DEVELOPMENT ASSESSMENT REPORT				
Application No.	REV/2021/0020			
Address	2/467-469 Liverpool Road CROYDON NSW 2132			
Proposal	S8.2 Review of Development Application - Enclosure of existing balcony of Unit 2			
Date of Lodgement	12 November 2021			
Applicant	Mr Timothy J Page			
Owner	Mr Timothy J Page Mrs Angela M Page			
Number of Submissions	Initial: 0			
Value of works	\$5,000.00			
Reason for determination at Planning Panel	Previous application refused under delegation			
Main Issues	Impacts on the streetscape, bulk and scale and loss of amenity			
Recommendation	Refusal			
Attachment A	Reasons for refusal			
Attachment B	Plans of proposed development			
Attachment C	Conditions of consent (if approved)

1. Executive Summary

This report is an assessment of the application submitted to Council pursuant to Section 8.2 of the Environmental Planning and Assessment Act 1979 for a review of Determination No. MOD/2021/0372, which refused the enclosure of the balcony with the installation of windows to Unit 2 at 467-469 Liverpool Road, Croydon. The application was refused for the following reasons:

2.04.00.0001 PROPOSED FRONT FACADE

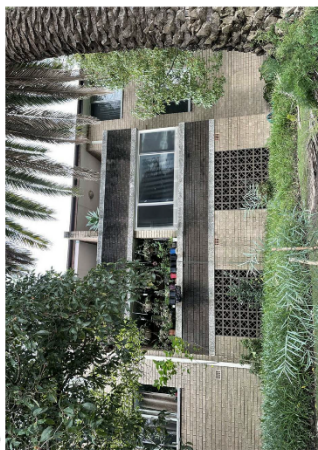
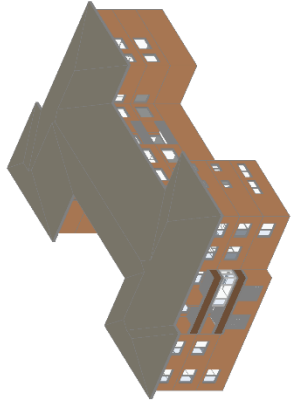
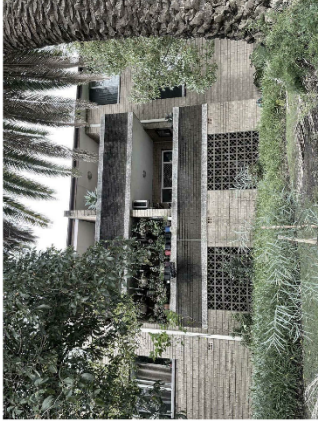
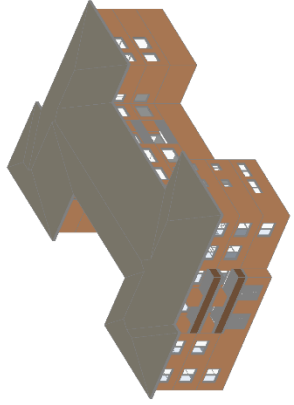
Comment: All balconies that front Liverpool Road within the RFB are currently open, the enclosure of one or more balconies is out of context and will negatively impact the character of the existing building, streetscape and neighbourhood.

Comment: Although the proposal seeks to install clear aluminium sliding windows that will match the existing windows within the building, the enclosure of the balcony will negatively impact the Liverpool Road streetscape and will be inconsistent with the form and style of the existing 1970's RFB.

Comment: All balconies that front Liverpool Road within the RFB are currently open, the enclosure of one or more balconies is out of context and will negatively impact the presentation of the existing building to Liverpool Road.

- a) Principle 1: Context and neighbourhood character: The proposal is not consistent with the character of the building and the established streetscape.

- d) Principle 9: Aesthetics: The proposal does not respond to the existing local context, particularly desirable elements such as open balconies of the streetscape.
